6PK1140SF – 6PK1070+T38427

VAG 1.6 Diesel: CAYB & CAYC + Air-conditioning

Fig. 1

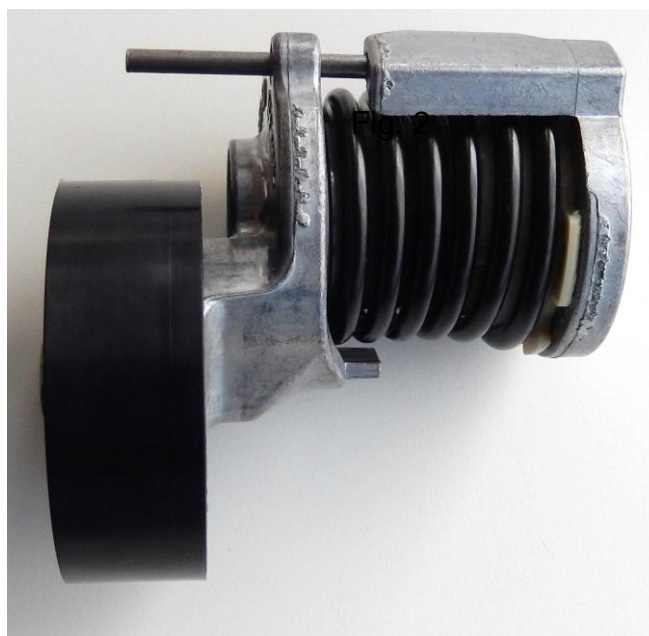
Changes to VAG 1.6 diesel CAYB & CAYC engines affect models equipped with air conditioning, from October 2009 onward. Classic Multi-Ribbed V-belts replace earlier elastic belts.

The Gates range includes Stretch-Fit™ belts for earlier applications that have not yet been adapted. Installation instructions and details about the correct tools required are printed on the inside sleeves and are also available from the online catalogue. Fig. 1 shows part of the initial procedure.
